VALUE ENGINEERING STUDY

Project # IMNH0-0285-01(352) PI No. 713300-

I-285 at Bouldercrest Road Interchange
DeKalb County, Georgia

23 February 2012

PROPOSAL NUMBER: R-15.1

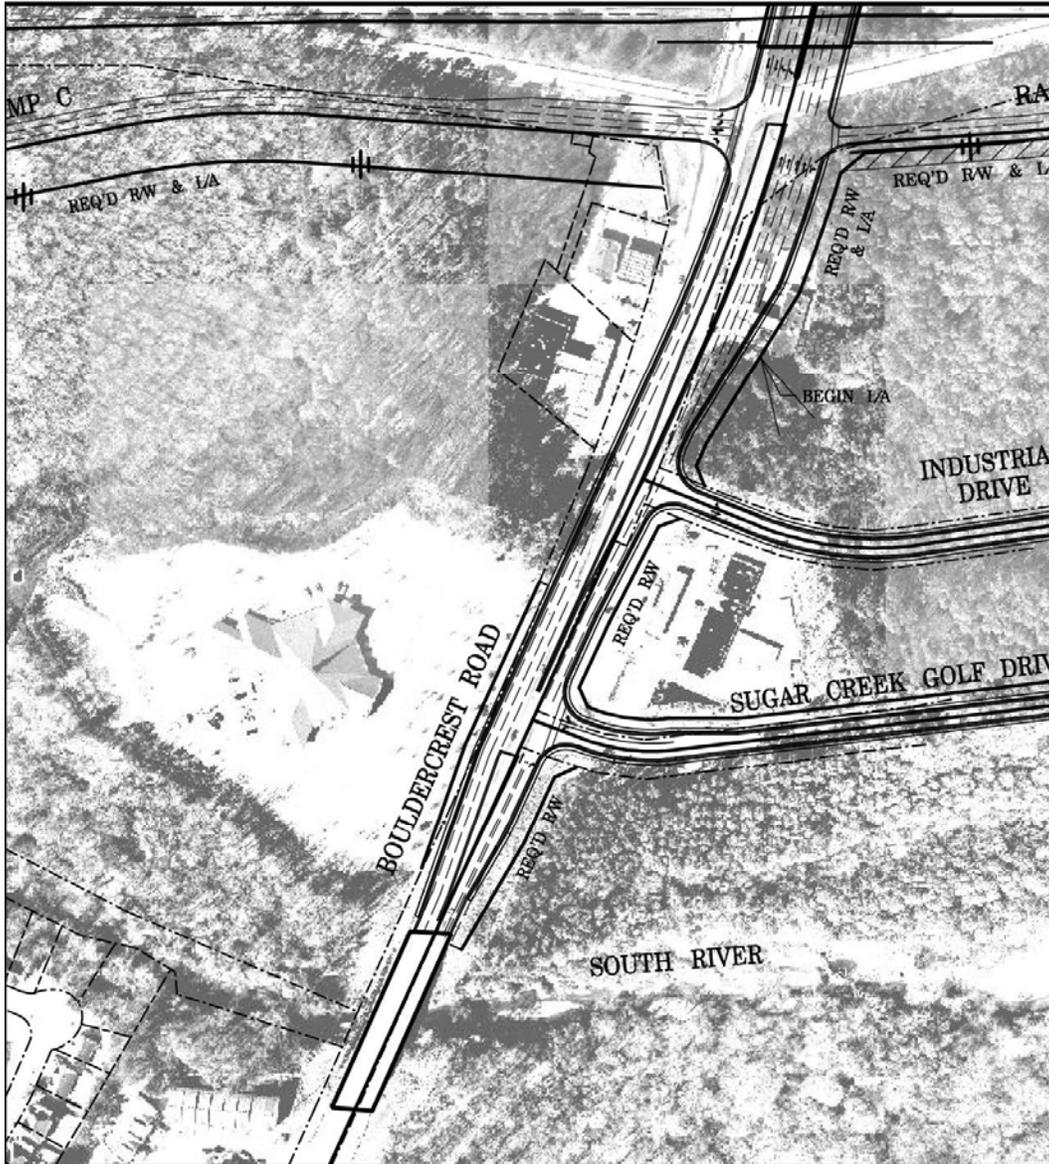
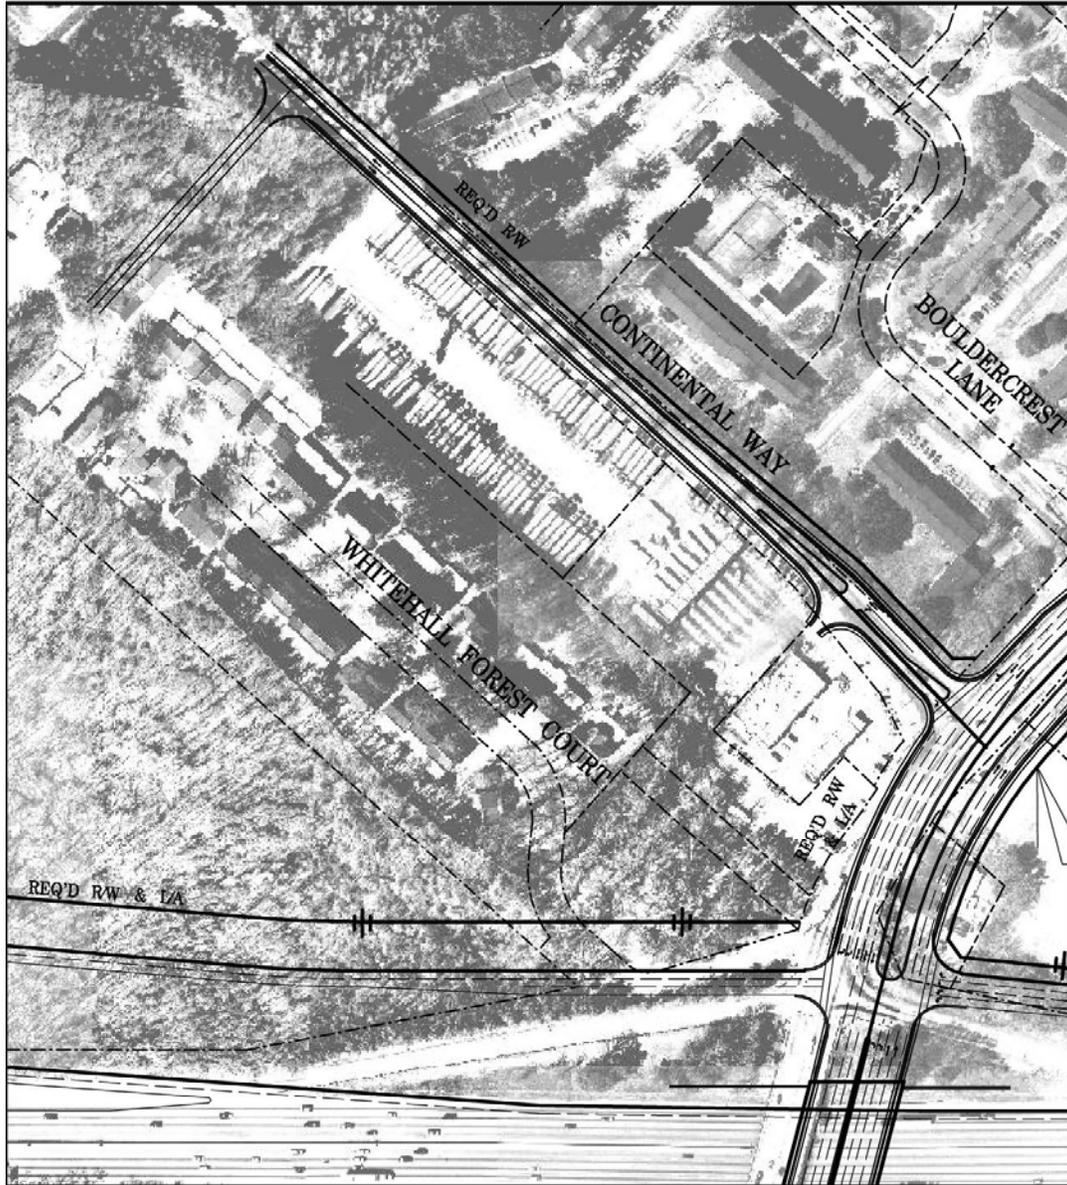
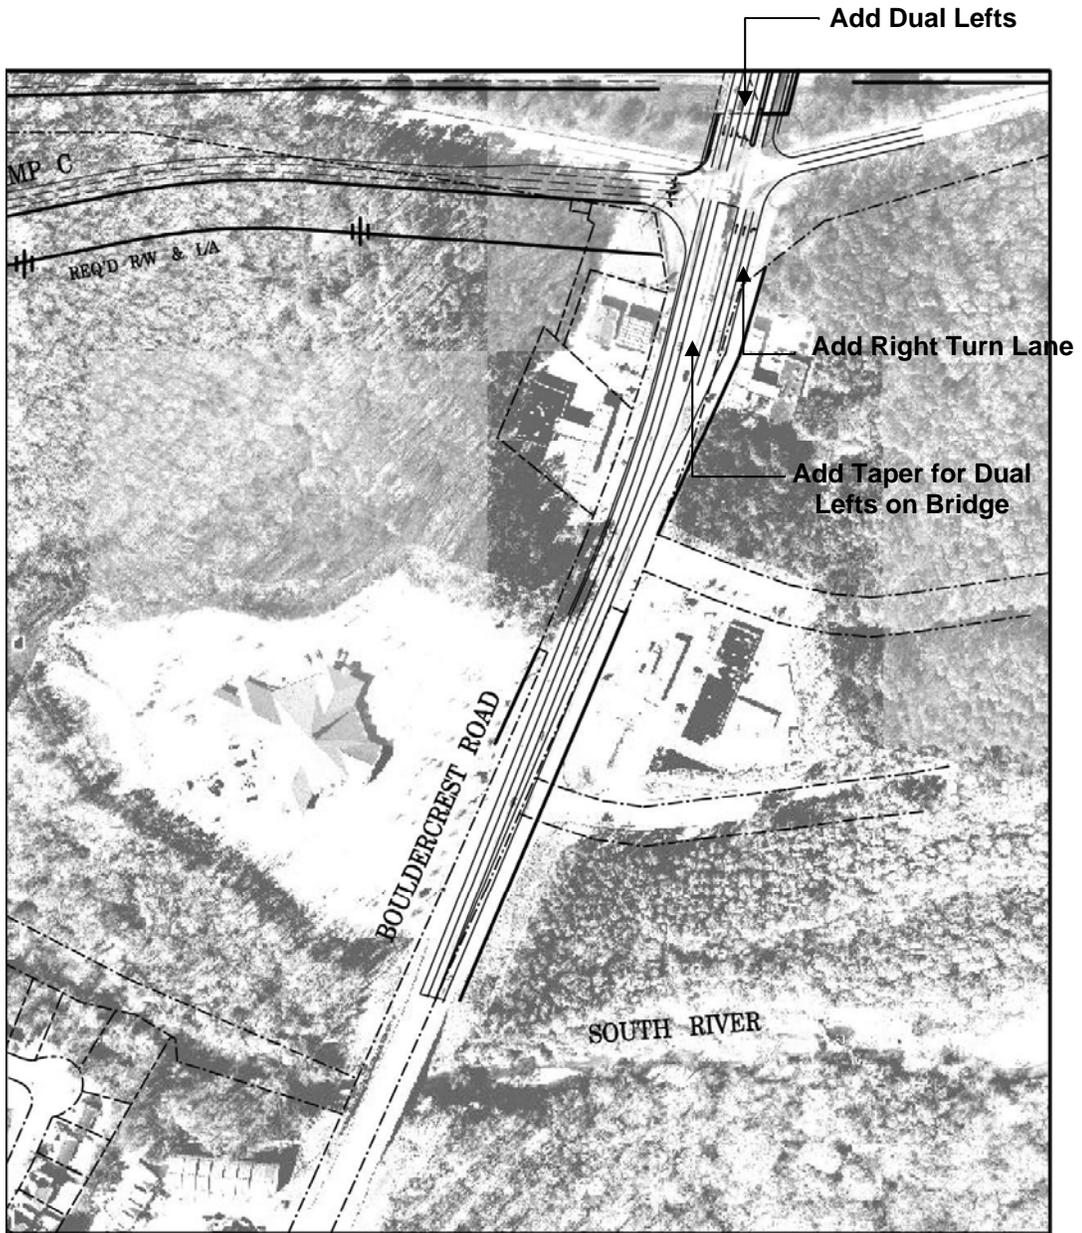
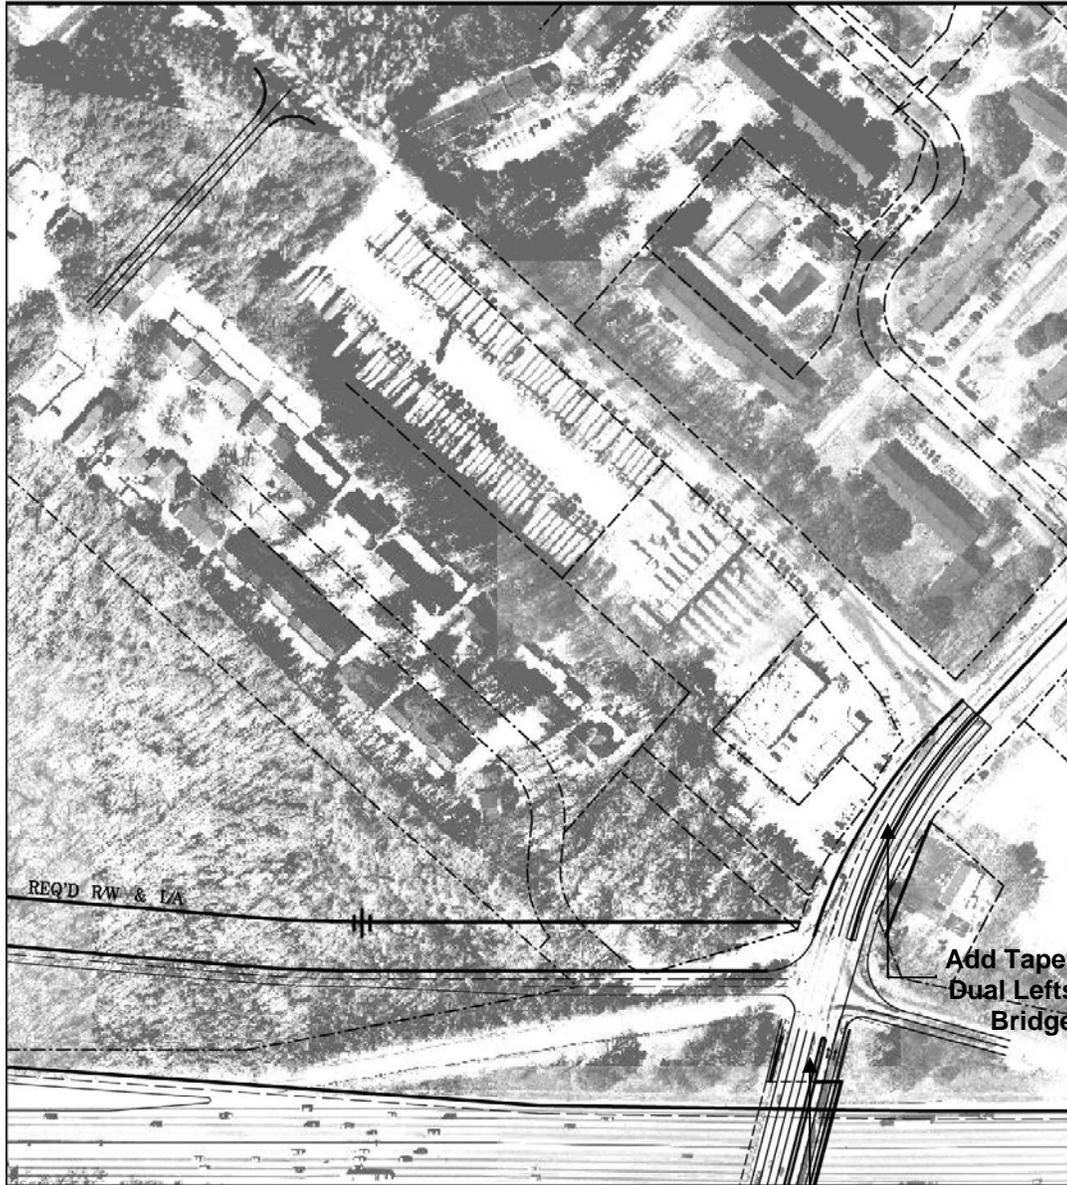
ORIGINAL DESIGN: The original design provides separate, isolated ramps in order to reduce weaving of exiting traffic from three systems affected: I-285, I-675, and Bouldercrest Road. This configuration uses multiple bridges to isolate ramp movements and braid traffic in an effort to improve operations along I-285 between I-675 and Bouldercrest Road. Bouldercrest Road also undergoes total reconstruction to provide truck traffic circulation due to ramp modifications and limited access R/W provisions.

PROPOSED CHANGE: It is proposed to limit the scope to focus on only those improvements necessary to improve operations on Bouldercrest and improve the current weaving condition on I-285. A traffic study showed that the only movements along Bouldercrest needing improvement are those to travel onto I-285 Eastbound. Thus, a revised scope will include widening of the existing Bouldercrest bridge over I-285 with a structure providing dual left turns in the Southbound direction and adequate capacity for through traffic growth. Also, construction of a Whitehall Forest Connector will be required off of Continental Way. The braided ramp approach is included in this scope to improve the weaving along I-285.

Add Dual
Lefts

Add Taper for
Dual Lefts on
Bridge
